November 8, 2005  
LIC-05-0119

**SUBJECT: Fort Calhoun Station Unit No. 1 License Amendment Request (LAR) 05-013,  
"Criticality Control During Spent Fuel Cask Loading in the Spent Fuel Pool"**

**"Criticality Control During Spent Fuel Cask Loading in the Spent Fuel Pool"**

Figure 2-11

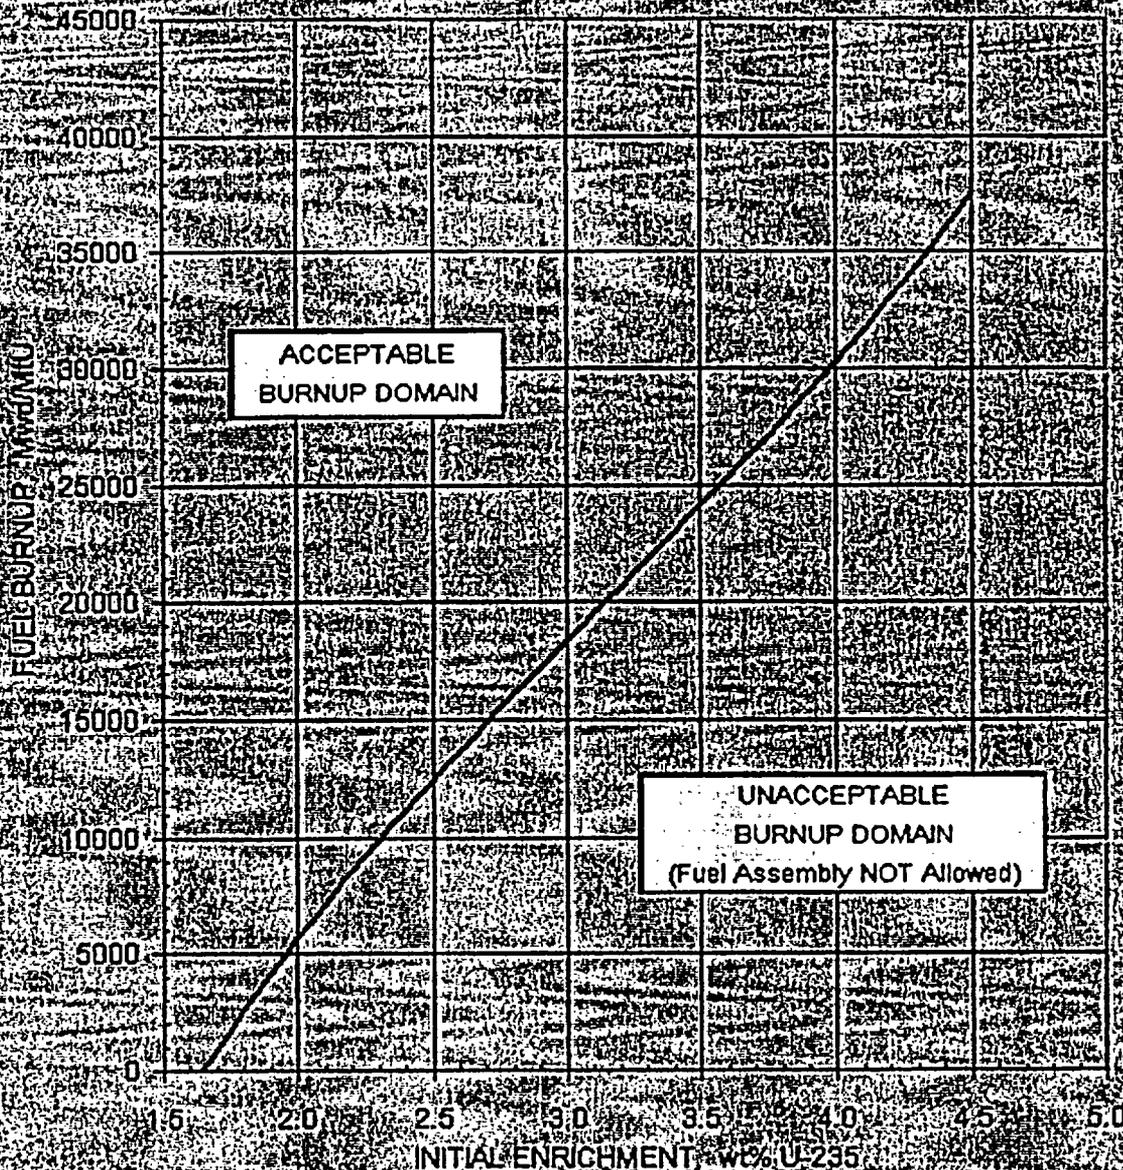
(2) The combination of initial enrichment and burnup of each spent fuel assembly located in a spent fuel storage cask in the spent fuel pool shall be within the acceptable burnup domain of Figure 2-1.1.

(3) With the requirements of the LCO 2.8.3(6)(2) not met, initiate action to remove the noncomplying fuel assembly from the spent fuel cask immediately.

Figure 2-11

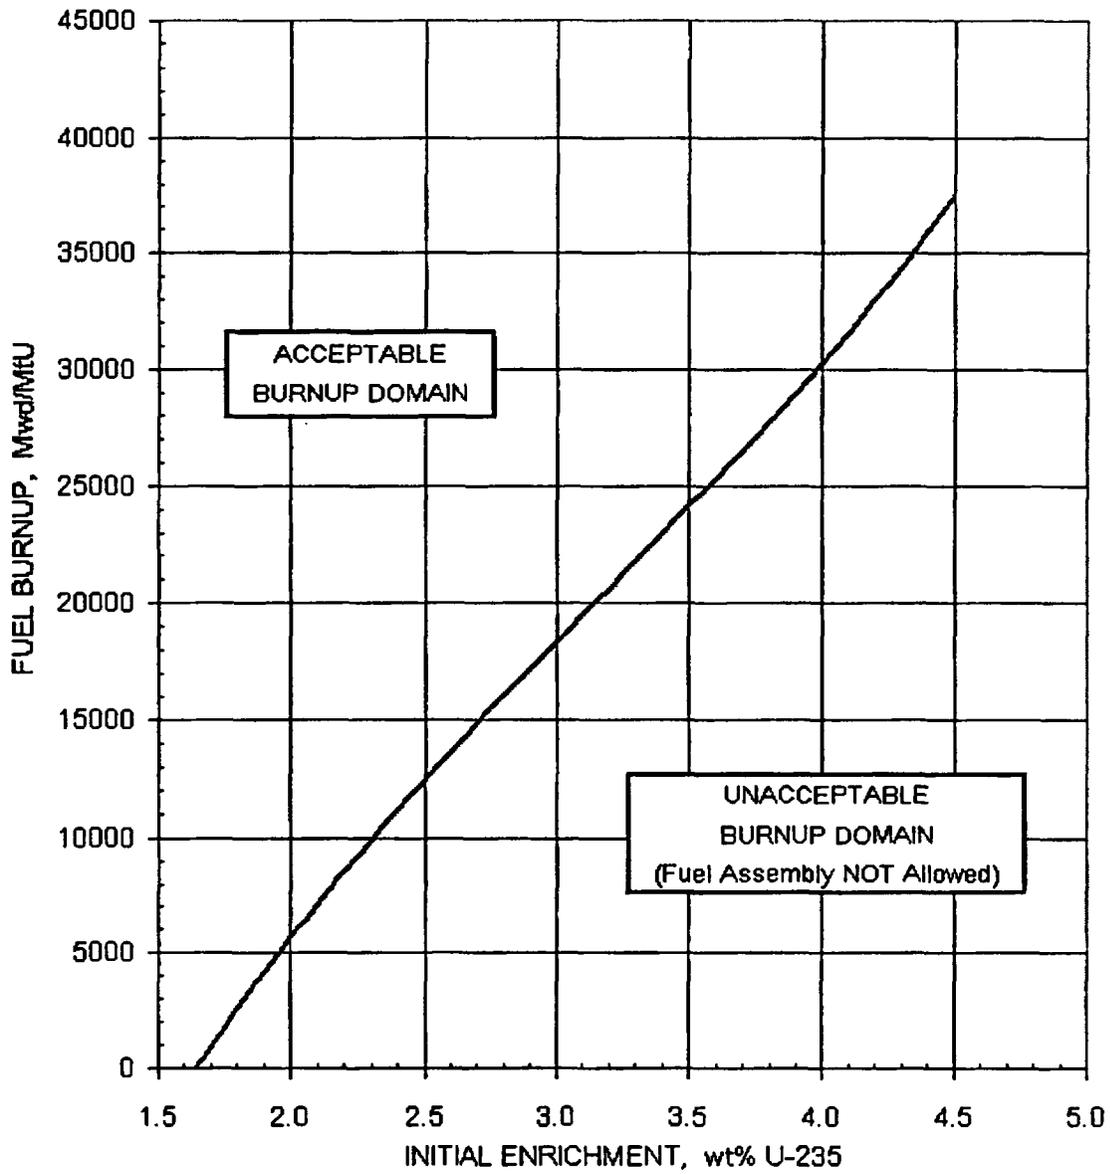
- (1) The spent fuel pool boron concentration shall be  $\geq 800$  ppm, and
- (2) The combination of initial enrichment and burnup of each spent fuel assembly located in a spent fuel storage cask in the spent fuel pool shall be within the acceptable burnup domain of Figure 2-11.

- (1) With the spent fuel pool boron concentration  $< 800$  ppm, suspend REFUELING OPERATIONS involving spent fuel cask loading immediately, and
- (2) Restore spent fuel pool boron concentration to  $\geq 800$  ppm immediately.
- (3) With the requirements of the LCO 2.8.3(6)(2) not met, initiate action to remove the noncomplying fuel assembly from the spent fuel cask immediately.
